Rezoning Transportation Analysis

Petition Number: #2022-037

Revision Log:

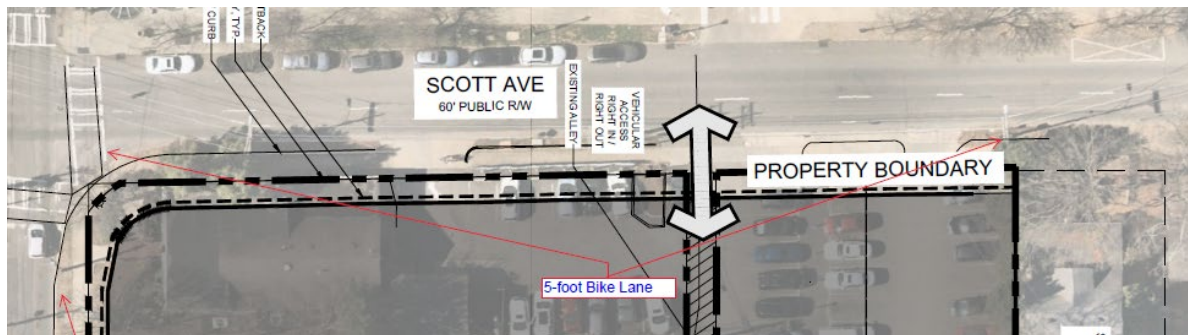
6. **Outstanding Comment from 08-23-2022:** Revise site plan and conditional note(s) to commit to widen Scott Avenue and provide a 5-foot bike lane across the site's frontage. **Note added (8/23/22)** The petitioner has requested to restripe the existing travel-way to match the Scott Avenue typical section south of East Blvd (5-ft bike lane without a buffer) if the existing travel-way can geometrically accommodate the existing on-street parking, 2-thru lanes and a 5' bike lane. Comment to remain until addressed or until CDOT evaluates and approves request. **Note added (1/26/23)** Confirm plan for Scott Avenue bike lane. Confirm that proposed Scott Avenue streetscape elements will be constructed at the future back of curb. Label and dimension streetscape elements from future back of curb.
